RFP 23-SFY-05
Uninterruptible Power Supply
Q & A

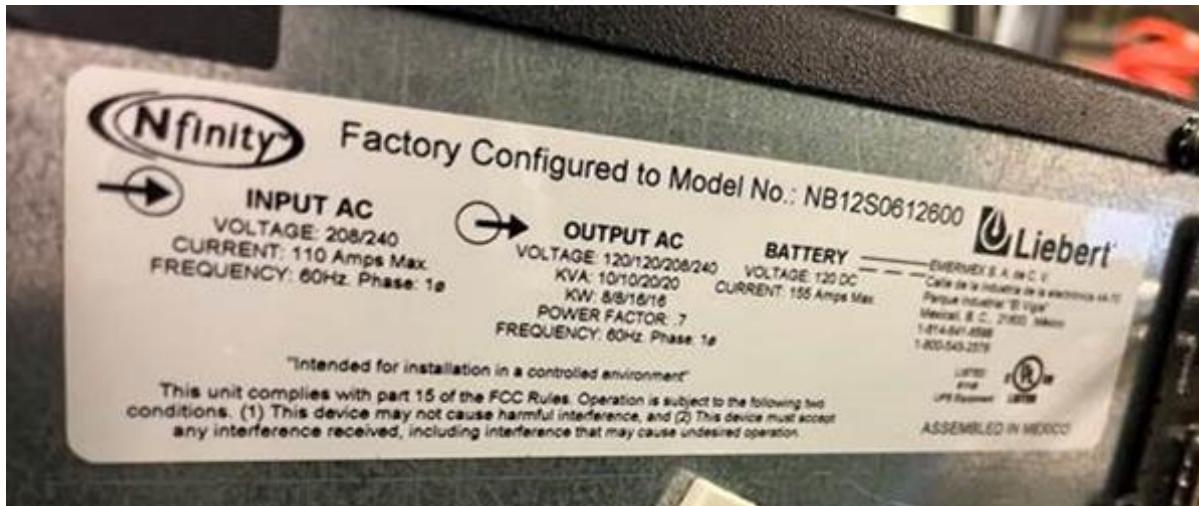
Q13. The RFP does not clarify if the existing UPS units are three phase UPS units or single phase.

1. CCDJFS- Single Phase. Please see label in Q14 and pictures in Q10
2. Clark County Jail – Based on the label it appears to be Single phase
3. Clark County Government Center - Based on the label it appears to be Single phase
4. Clark County Information Systems – Not sure but appears to be 3 phase, based on the label.

1. CCDJFS

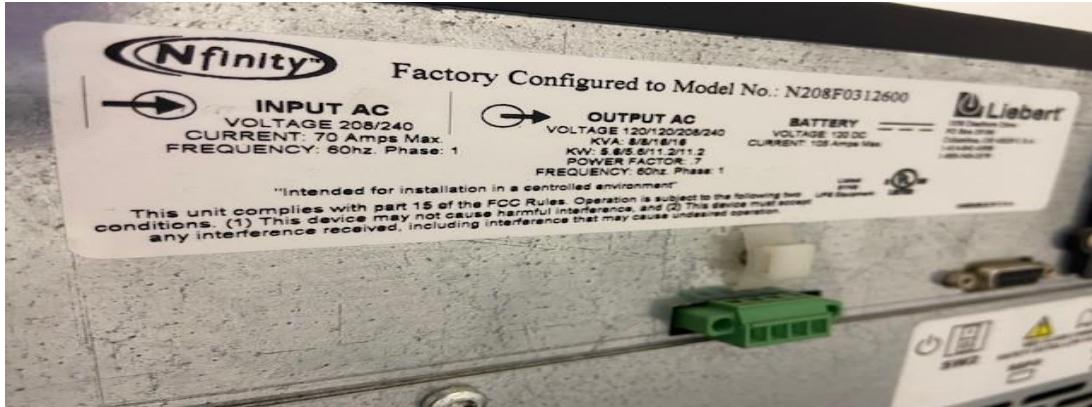
Q14. Manufacturers label plate information for the existing UPS units would help determine the proper UPS design.
